DOCUMENT TO: Ms. Barbara Winicoll ORGANIZATION: EPA
 ORIGINATOR NAME: Ted Taylor ORGANIZATION: DOE
 SYMBOL: _____ DOCUMENT DATE: _____
 SUBJECT/TITLE: Modification to the Environmental Protection Agency Approved Pilot Study Plan for Material Disposal Area (MDA) 2 at Operable Unit (OU) 1148 Draft

**SUBJECT: MODIFICATION TO THE ENVIRONMENTAL PROTECTION
AGENCY APPROVED PILOT STUDY PLAN FOR MATERIAL
DISPOSAL AREA (MDA) L AT OPERABLE UNIT (OU) 1148**

**PROPOSED ACTION PLAN
DRILLING NEAR AREA L
TA-54, OU 1148**

Location map of planned boreholes and pilot tests

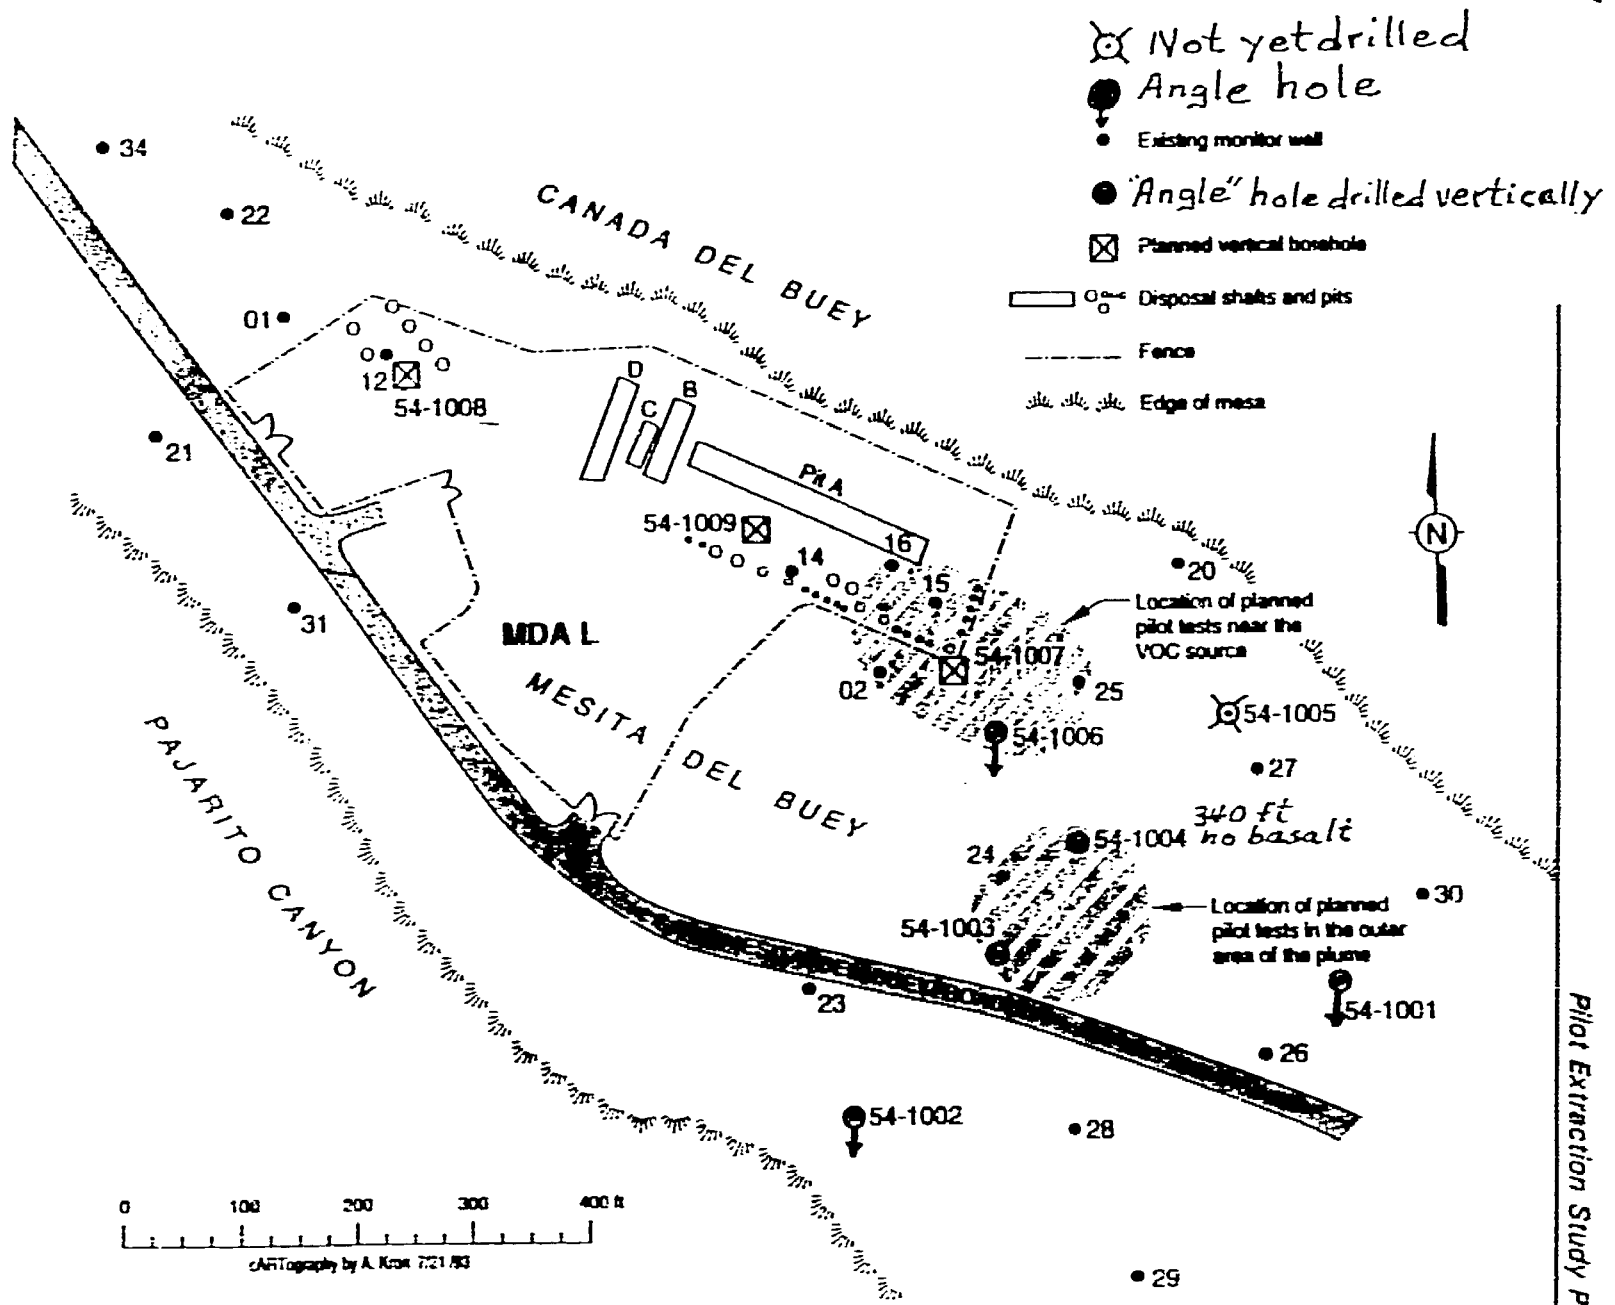
Five of the six angle holes have been drilled by hollow stem auger (see the attached map). As indicated by arrows on the map, holes 54-1001, -1002, and -1006 were drilled at angles between 20 and 25 degrees from vertical, toward the South. In each hole, the tuff extends to about 160 feet. Below the tuff is a unit of weak ash and pumice that we believe will not support a fracture. In an attempt to obtain better samples in the weak material, it was decided to drive the sampling tube ahead of the auger with a downhole hammer. This scheme did not work properly at a non-vertical angle; consequently, holes 54-1003 and -1004 were drilled vertically. The first four holes reached basalt at about 290 feet of vertical depth below the top of casing. However, the fifth hole of the sequence (54-1004) was terminated at the 340-foot depth limit of the auger rig without reaching basalt. Basaltic cobbles were noted near 300 feet, with ash below that level. The lower ash appears to be of different origin than the material lying between 160 and 300 feet. Borehole video reveals that unconsolidated powder fills hole 54-1003 at 250 feet, although it was drilled to 299 feet. Borehole video found that powder fills the other four holes at depths of ten to forty feet above the drilled bottom.

Except for the fact that the basalt is deeper or nonexistent at hole 54-1004, all five holes reveal the same stratigraphy. Because little new information would be gained from one additional hole at its location, the drilling of 54-1005 was postponed. We propose below that it be drilled in the future at a location closer to 54-1004 or at another location determined from the data of the first five holes.

Field screening detected volatile contaminants extending to the basalt in hole 54-1006 (the angle hole nearest the disposal shafts), but did not detect VOCs in the lower regions of the other four holes.

Angle holes. Because there is no immediate need for more stratigraphic data, we propose to postpone drilling of the sixth angle hole. The laboratory analysis of the VOC content in cores from the previous five angle holes may reveal the need for placing 54-1005 in a different location. Meanwhile, we will evaluate the possibility of extending hole 54-1004 (by air rotary) until the basalt is located. If the top of the basalt is anomalously deep at 54-1004, hole 54-1005 might be located so as to explore further the ash-basalt contact. (Although the air rotary extension of hole 54-1004 might cause a cavity in the soft material, 54-1004 is located some 200 feet from the nearest disposal unit. A cavity at 54-1004 would have a smaller impact on contaminant migration than a cavity closer to a disposal unit.)

Deep vertical holes. We propose that these holes not be drilled as planned because of the potential for creating cavities in the weak material below the disposal units. We propose to drill three vertical holes by auger to a depth of 150 feet (within consolidated tuff) at these locations, obtaining continuous core with sampling of core at the intervals specified in the pilot study plan. Gas samples would not be collected during drilling. Because the soil is very dry, we expect that only volatile contaminants have migrated to depths greater than 150 feet; therefore, the proposed action would reveal the vertical extent of non-volatile contamination, just as well as the original deep drilling. The holes would be backfilled with cuttings (per LANL SOP) and then grouted and abandoned.
